**CITY OF VANCOUVER  
DEVELOPMENT, BUILDINGS, & LICENSING**

**DEVELOPMENT PERMIT STAFF COMMITTEE  
MEETING  
April 13, 2022**

**1025 Dunsmuir (COMPLETE APPLICATION)  
DP-2021-00824–DD ODP**

Figure 2: Building's massing and architectural expression

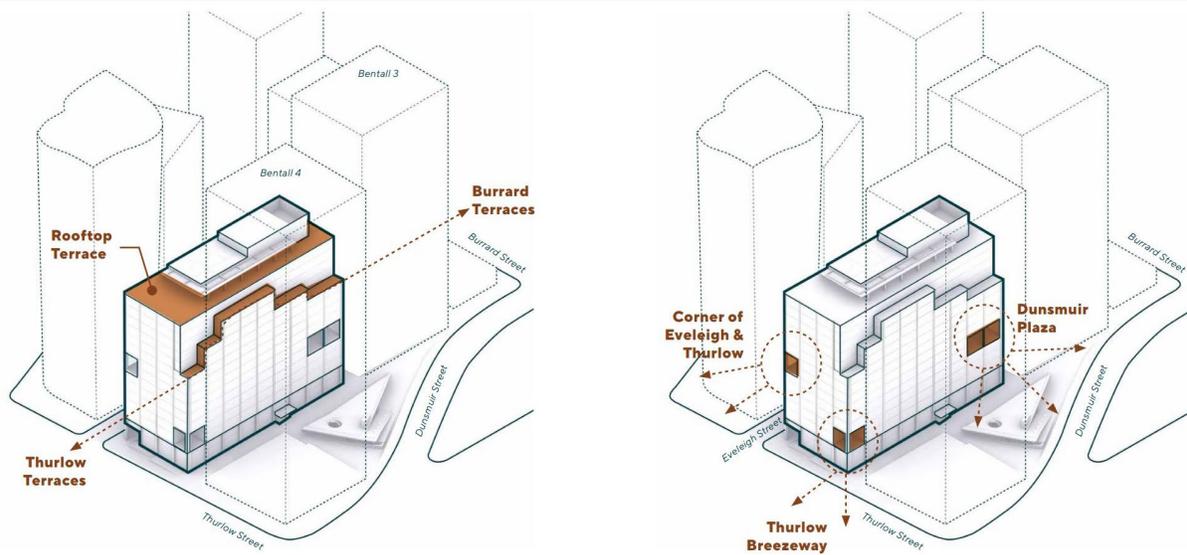
The one-storey timber pavilion is introduced at the plaza for people's engagement and participation. However, the design of the pavilion and the way it connects to the plaza raised as a key consensus item by the Urban Design Panel. The panel recommended that the plaza, and pavilion design should be reconsidered in order to better respond to what is best needed in this area. Considering the Urban Design Panel's recommendation, City Staff seek further refinement to the pavilion and plaza to better respond to the character of the urban context. Particularly, further care should be given to how the pavilion's design and expression can be better resolved. In addition, staff seeks improvements of the public plaza and the landscape strategy of the plaza as a prominent public space at downtown business district. The details of these refinements are outlined in ***Recommended Conditions Error! Reference source not found. and Error! Reference source not found..***

- 1.1 Design development to improve the function and performance of the plaza by:
- i. re-locating the pavilion to reduce shadowing on the plaza from 2:00 pm to 4:00 pm PDT on the Spring and Fall equinoxes;
  - ii. reflecting the character-defining elements of the Bentall Centre campus by:
    - a. introducing distinctive landscape features and site furnishings;
    - b. introducing feature lighting to highlight unique site elements and to provide visual interest at all hours; and
    - c. incorporating other elements to enhance activity, animation, functionality, and safety;
  - iii. reducing the Bentall #4 entry patio to mitigate obstructions to pedestrian flow through the plaza;

- i. significantly reducing the size of the pavilion;
- ii. removing occupied roof area;
- iii. reducing overhangs; and
- iv. removing bleachers;

Figure 3: Overall Site Plan

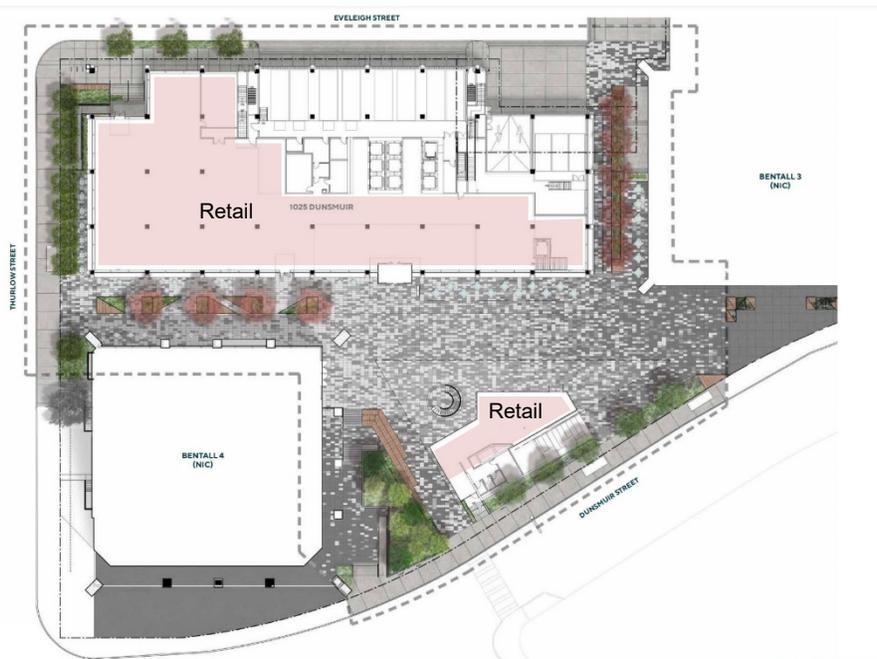
However, as noted at Urban Design Panel, staff have concluded that the design of pavilion and its relationship to the plaza should be revised in order to better respond to the quality of public realm and the character of downtown Vancouver. This concern has been reflected in Recommended Conditions 1.1 and 1.2.
